Revision: 1	keith@keith-snook.info	Page Size: A4
<h1>QUAD MPX Decoder</h1>		
24 June 2011	Drawn: K. Snook	Page 1 of 1

Revision: 2	keith@keith-snook.info	Page Size: A4
QUAD MPX Decoder Silicon Mod		
28 June 2011	Drawn: K. Snook	Checked:
		Page 1 of 1

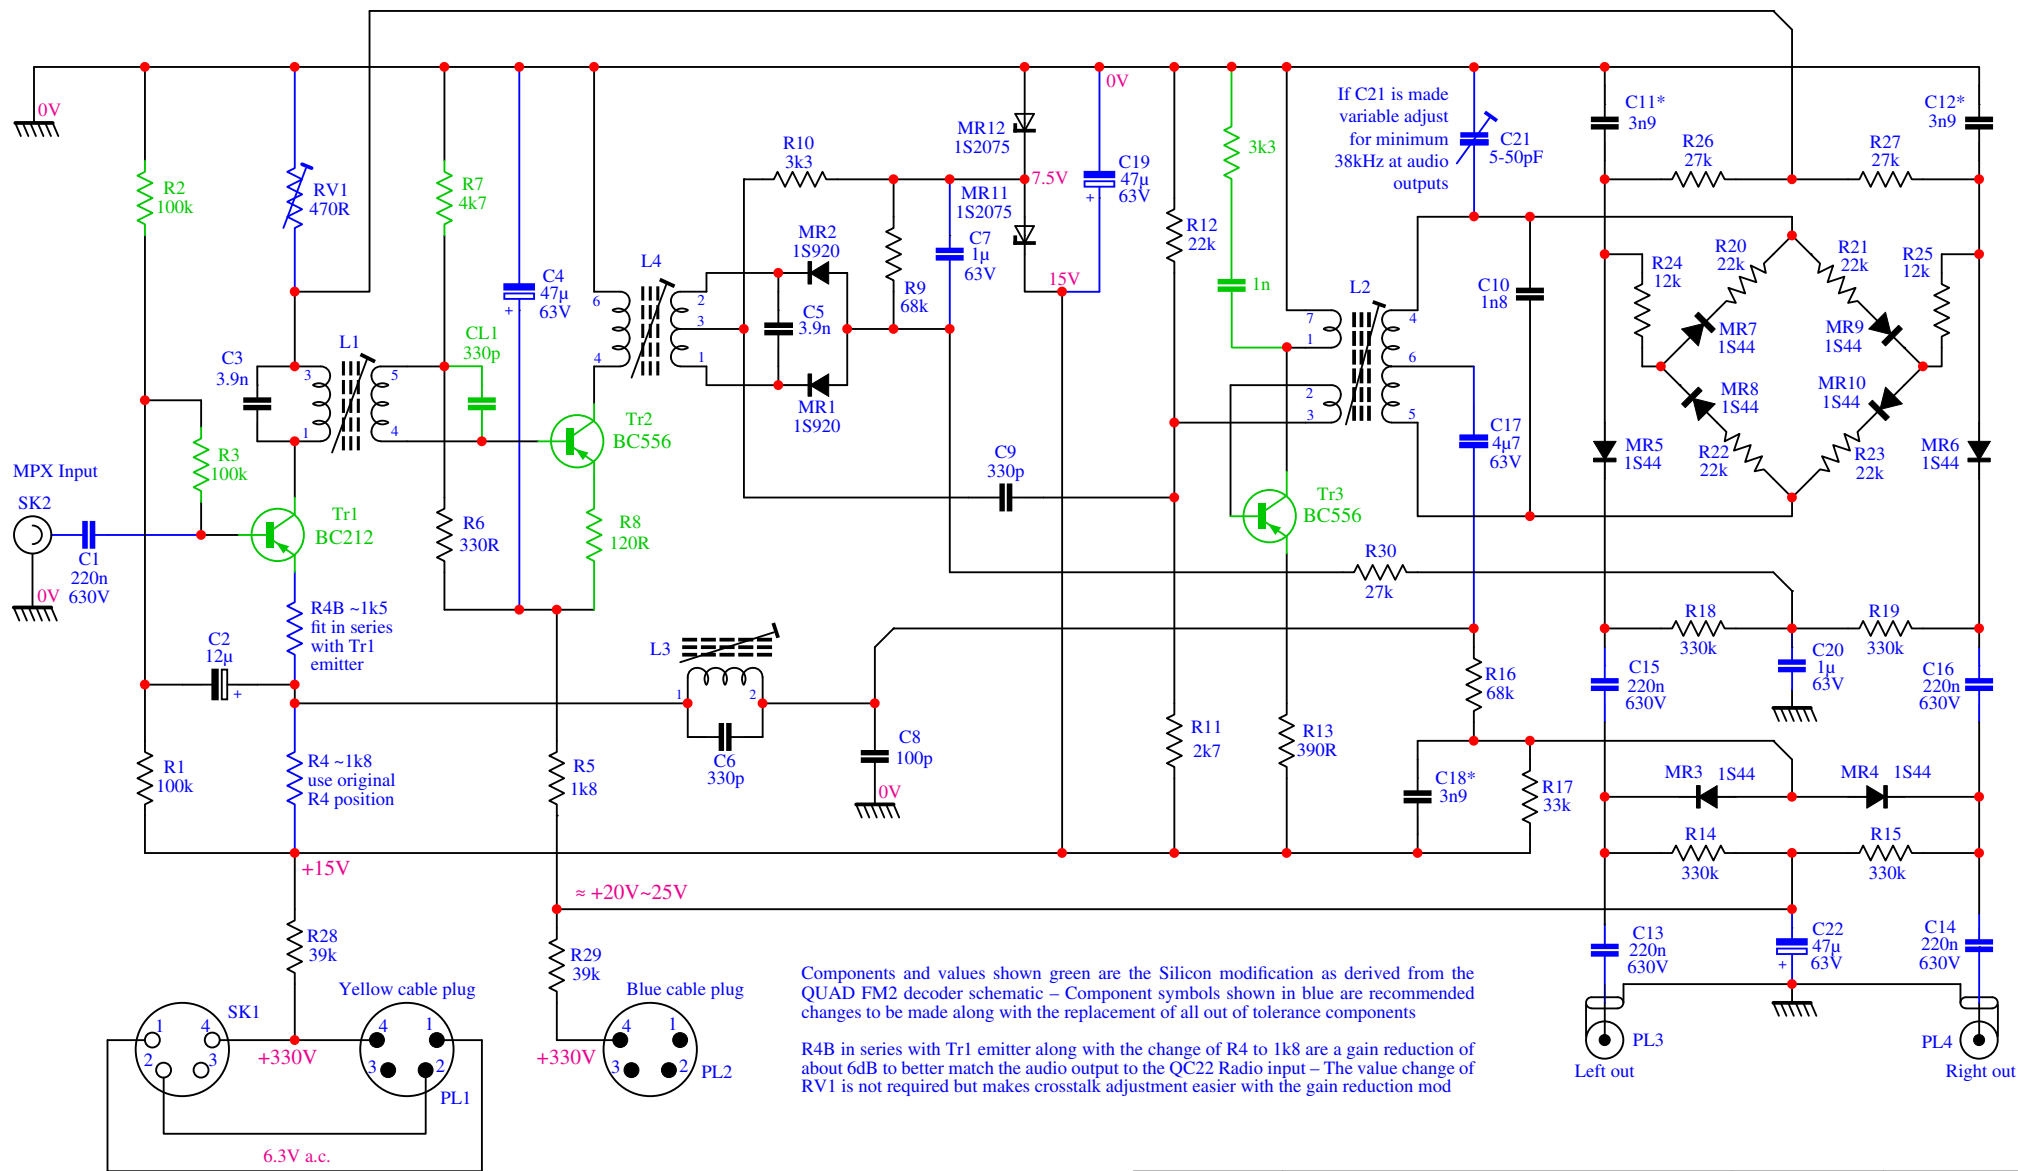
For stereo only listening (as most stations now stereo)
 Yellow and Blue plugs can be swapped at QUAD 22
 to reduce the load on the yellow channel power amp

Components and values shown green are the Silicon modification as derived from the QUAD FM2 decoder schematic – Component symbols shown in blue are recommended changes to be made along with the replacement of all out of tolerance components

R4B in series with Tr1 emitter along with the change of R4 to 1k8 are a gain reduction of about 6dB to better match the audio output to the QC22 Radio input – The value change of RV1 is not required but makes crosstalk adjustment easier with the gain reduction mod
